Service Bulletin

SUBJECT: Service Update for Inventory and Customer Vehicles
Turbo Vacuum Hose Routing - Inspect
Expires with Base Warranty

MODELS: 2014 Cadillac XTS
Equipped with 3.6L V6 Engine (LF3)

Subject: 13275 – Service Update Bulletin
Turbo Vacuum Hose Routing – Inspect

Incorrect Routing

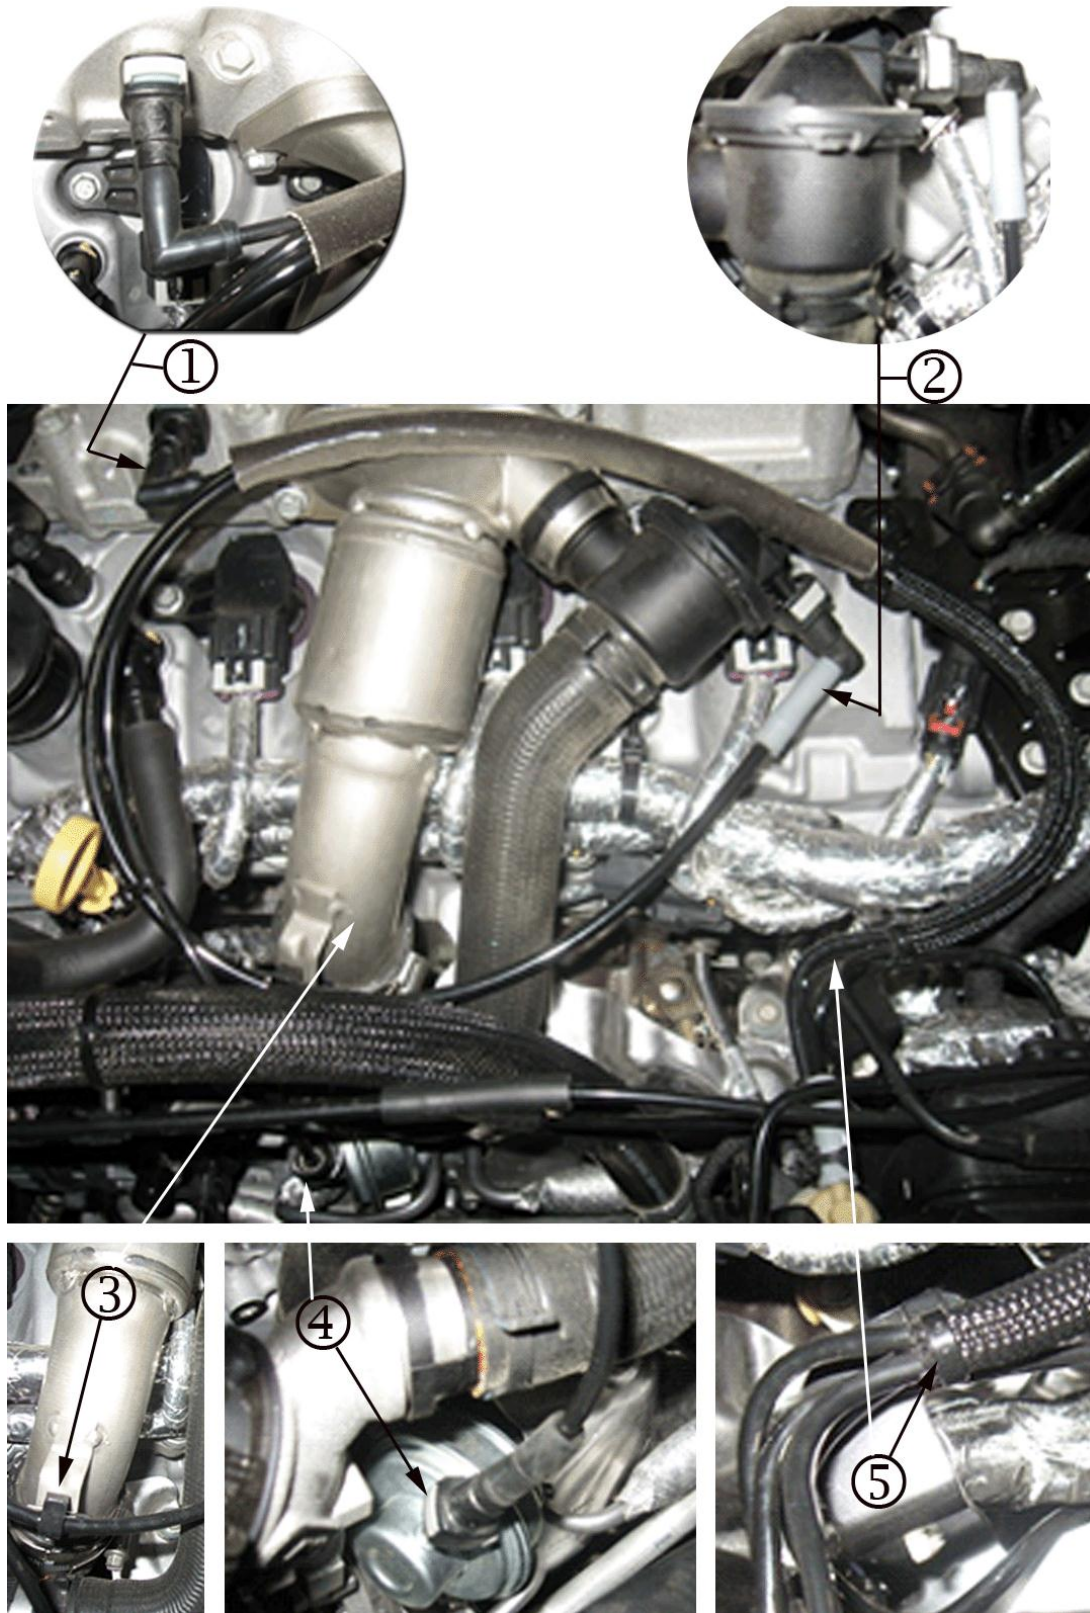
3. Determine if the turbo charger wastegate actuator vacuum boost tube bundle for the left cylinder bank is properly routed and free from kinks.

- If the turbo charger wastegate actuator vacuum boost tube bundle (1) is NOT routed correctly, disconnect the tube bundle from the attachment points and re-route the tube bundle. Install the intake manifold cover and front compartment front sight shield AFTER completing the repair. Refer to *Intake Manifold Cover Replacement* and *Front Compartment Front Sight Shield Replacement* in SI. Refer to the following sections in this bulletin for information about how to correctly route the turbo charger wastegate actuator vacuum boost tube bundle:
 - Charge Air Bypass Valve Vacuum Tank Tube Routing and Connection Aids on Engine
 - Charge Air Bypass Valve Vacuum Tank Tube Routing and Connection Aids At Turbo Wastegate Regulator Solenoid

Charge Air Bypass Valve Vacuum Tank Tube Routing and Connection Aids on Engine

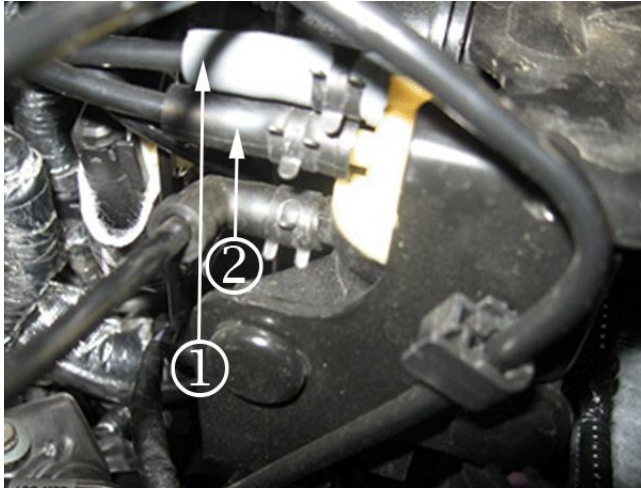
Black 90 Degree Connector (2) Gray 90 Degree Connector (3) Gray 90 Degree Connector Tube Attachment Clip Point (4) Black Straight Turbo Actuator Connection (5) Christmas Tree Fastener Attached to Bracket Hole

Charge Air Bypass Valve Vacuum Tank Tube Routing and Connection Aids At Turbo Wastegate Regulator Solenoid

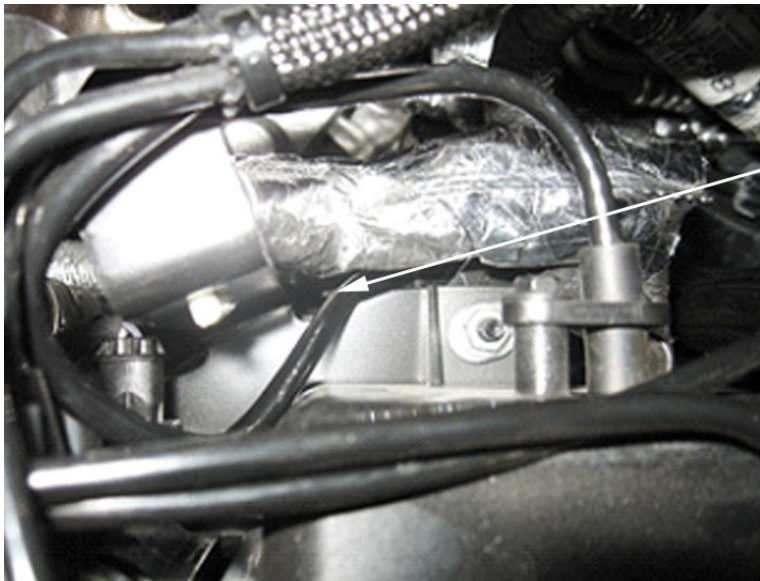
- (1) Straight Gray Tube Connection (Side View)
- (2) Straight Black tube Connection (Side View)
